[Docket No. 2000-CE-44-AD; Amendment 39-12920; AD 2002-21-13]

Airworthiness Directives; Raytheon Aircraft Company Beech Models 35, 35R, A35, and B35 Airplanes

ACTION: Final rule.

Figure 1

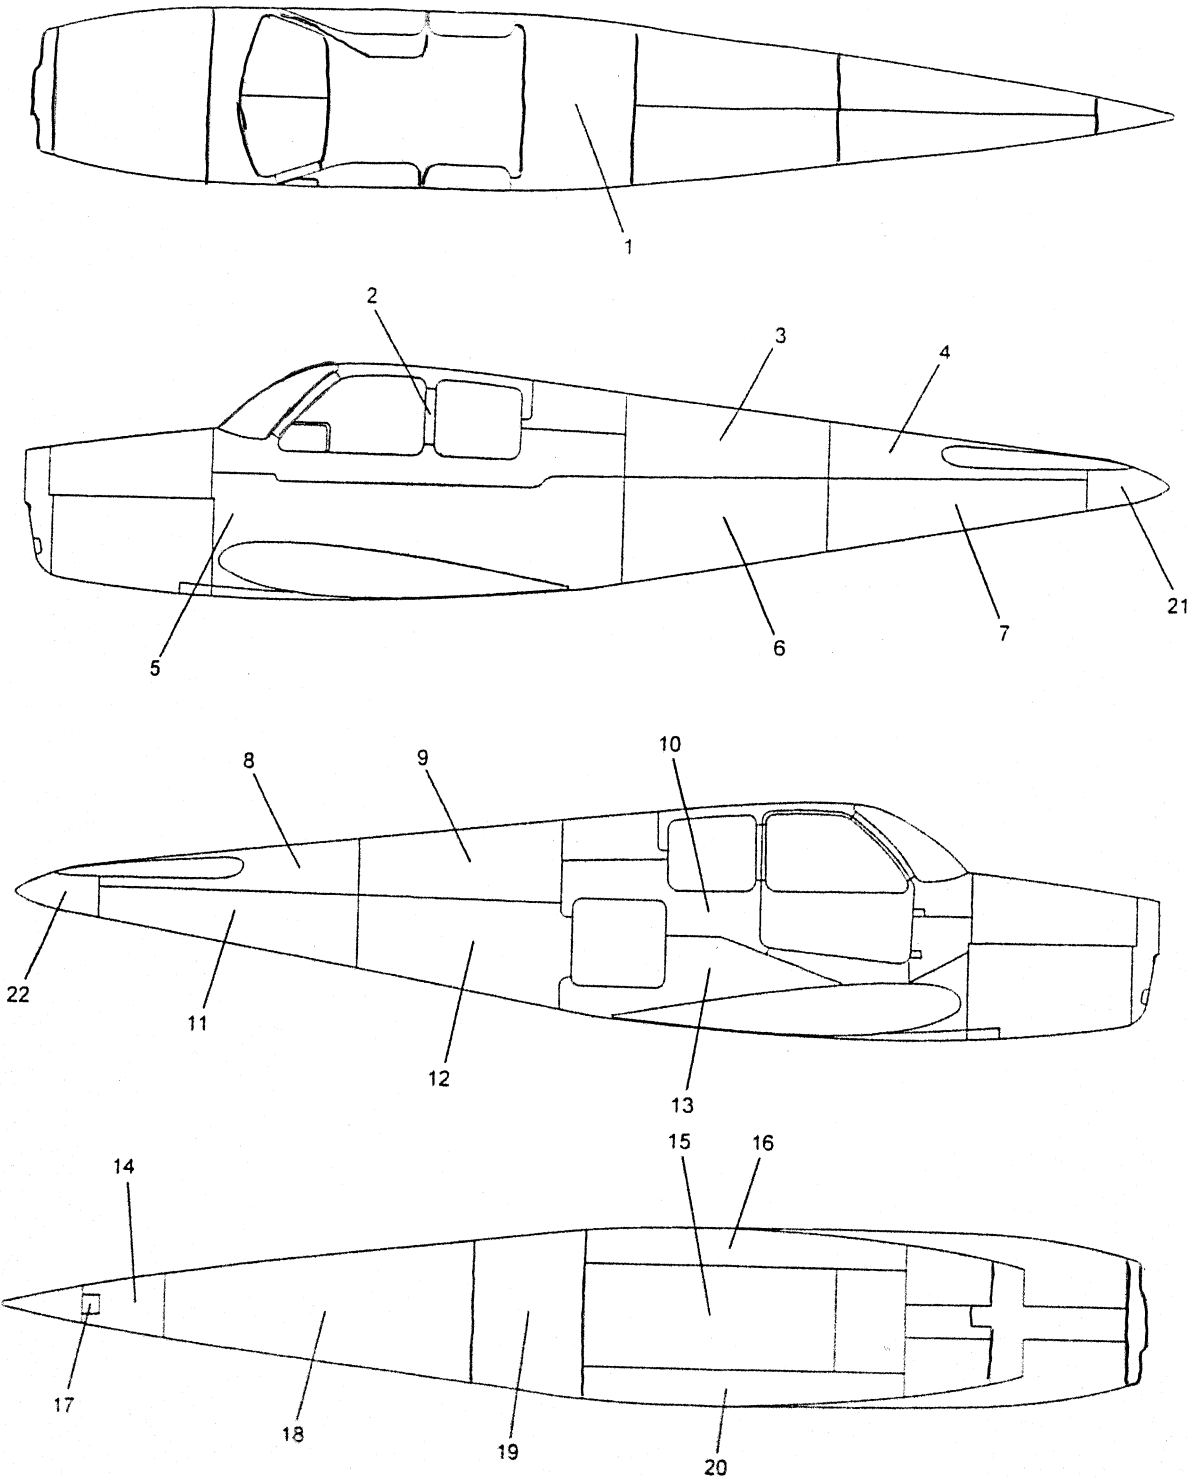
concern is specifying only one piece of equipment. These same commenters also state that there are differences in skin thickness, e.g., 0.016 inch instead of 0.018 inch.

We also concur that there are differences in skin thickness. We are adding to the final rule AD action reference to the different skin thicknesses that are specific to each airplane serial number and the location (fuselage stations) of each affected skin part number.

(5) Visually inspect the empennage, aft fuselage, and ruddervator control system for damage: (i) Part of this is an inspection of the aft fuselage skin for wrinkles or cracks. Specific skin thicknesses are presented in Figures 1 and 2 of this AD. The skin thickness measurement is not repetitive. (ii) The inspection and setting of the travels on the elevator and elevator trim tabs are not repetitive. (iii) Repair or replace any damaged parts and set the elevator controls, rudder and tab system controls, cable tensions, and rigging.	Inspect within the next 100 hours TIS after the last inspection required by AD 94-20-04 or within the next 25 hours TIS after December 10, 2002 (the effective date of this AD), whichever occurs later, and thereafter at intervals not to exceed 100 hours TIS, except for the skin thickness measurement and the inspection and setting of the travels on the elevator and elevator trim tabs, which are one-time actions. Accomplish any repairs, replacements, and adjustments prior to further flight after the applicable inspection.	Accomplish the inspection and repairs or replacements in accordance with the procedures in paragraphs (5)(a) through (5)(f) of the ACCOMPLISHMENT INSTRUCTIONS section of Raytheon Service Bulletin No. SB 27-3358, Issued: February, 2000, and use a digital ultrasonic skin tester or equivalent skin tester or direct methods that utilize calipers and micrometers. Specific skin thicknesses are contained in Figures 1 and 2 of this AD.

(e) *Where can I find Figures 1 and 2 of this AD?* Figures 1 and 2 of this AD, as referenced in paragraph (d)(5)(i) of this AD, follow:
